Work Order ID 71820

Item Name: Crosstube Turning Detail

DART AEROSPACE LTD	Work Order: 71820
Description: Crosstube Assembly	Part Number: D407-667-245
Inspection Dwg: D407-667-245 Rev: F	Page 1 of 1

DRAWING NO. D407-667-245	TITLE CROSSTUBE ASSY (407 HIGH AFT)	REV. F	DART AEROSPACE LTD ENGINEERING ORDER		D.E.O. NO. D407-667-245-F-1	SHEET NO. SHEET 1 OF 2	SCALE NTS
DRAWN <i>JS</i>	CHECKED <i>JP</i>	MFG. APPR. <i>E</i>	APPROVED <i>JP</i>	DE APPR. <i>JP</i>			
DATE 11.04.08	DATE 11.04.12	DATE 11.04.12	DATE 11.04.12	DATE 11.04.12	DATE 11.04.12

DRAWING NO. D407-667-245	TITLE CROSSTUBE ASSY (407 HIGH AFT)	REV. F	DART AEROSPACE LTD ENGINEERING ORDER	D.E.O. NO. D407-667-245-F-1	SHEET NO. SHEET 2 OF 2	SCALE NTS
DRAWN	CHECKED	MFG. APPR.	APPROVED	DE APPR.		
DATE 11.04.08	DATE 11.04.11	DATE 11.04.12	DATE 11/04/12	DATE 11.04.12

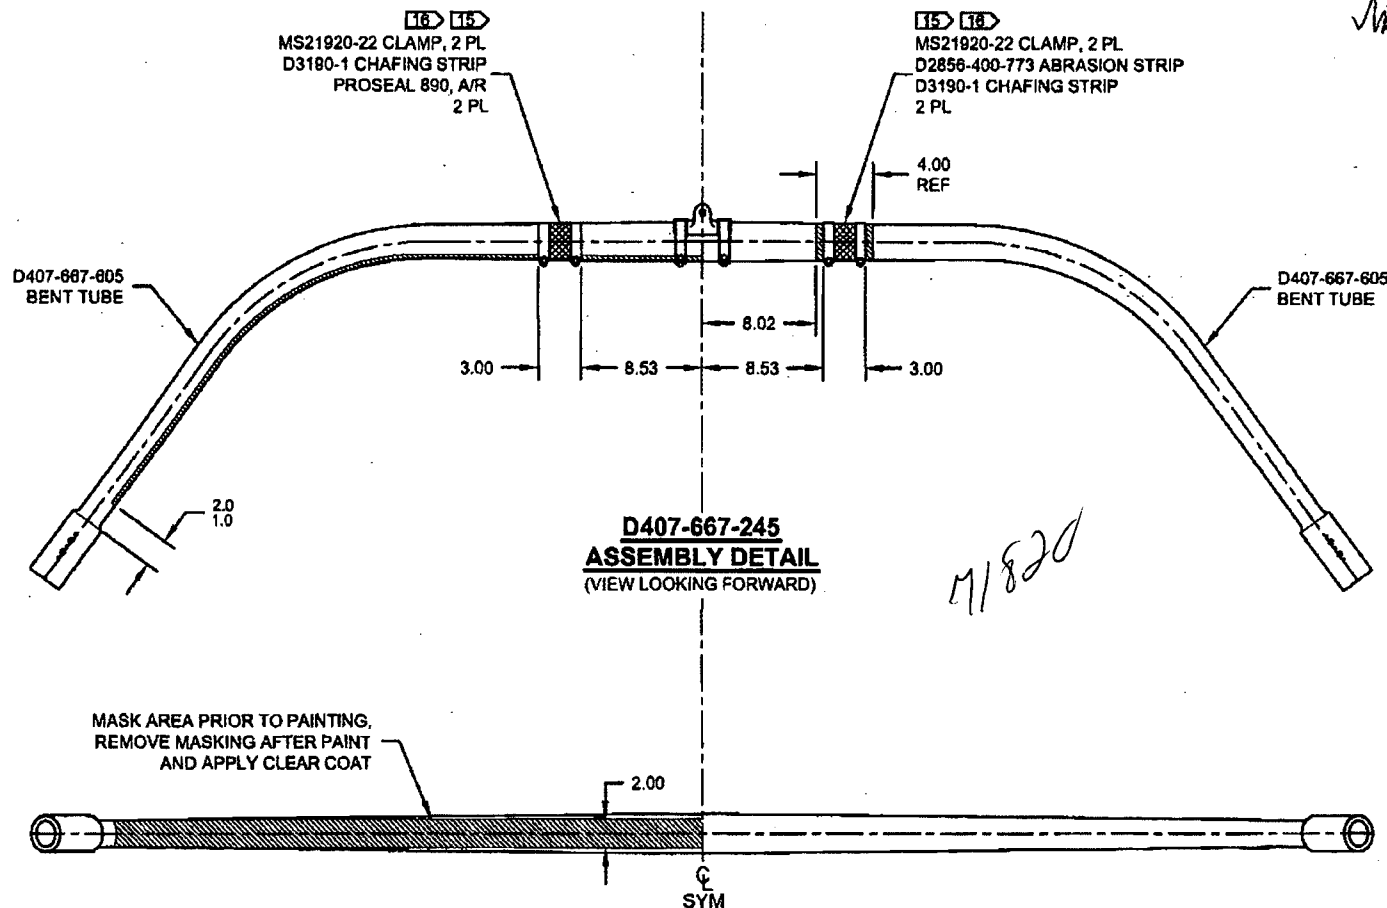
PURPOSE:

REMOVED ABRASION STRIP IN FAVOR OF A THIN LAYER OF PROSEAL 890.

NOTES 2 AND 15, SHEET 1 ARE AMENDED AS FOLLOWS:

- 2) FINISH: CHEMICAL CONVERSION COAT PER DART QSI 005 4.1
PRIME INSIDE AND OUTSIDE PER DART QSI 005 4.2
PAINT OUTSIDE PER DART QSI 005 4.2
- 15) INSTALL D2856-400-773 ABRASION STRIP WITH A 0.13 REF GAP ON BOTTOM SIDE OF
CROSSTUBE PER QSI 035.

- 2) FINISH: CHEMICAL CONVERSION COAT PER DART QSI 005 4.1
PRIME INSIDE AND OUTSIDE PER DART QSI 005 4.2
MASK UNDERSIDE OF CROSSTUBE AS SHOWN (HATCHED AREA) AND
PAINT OUTSIDE PER DART QSI 005 4.2
REMOVE MASKING AND APPLY CLEAR COAT
- 15) APPLY A THIN COAT OF PROSEAL 890 ON INSIDE CONCAVE SURFACE OF D3190-1
CHAFING SHIELDS AND LET CURE PER MANUFACTURER'S INSTRUCTIONS. INSTALL
PROSEALED D3190-1 CHAFING SHIELDS ONTO CROSSTUBE BY APPLYING A THIN COAT
OF PROSEAL 890 ONTO CROSSTUBE. BE SURE TO ELIMINATE ANY AIR GAPS.

IS:
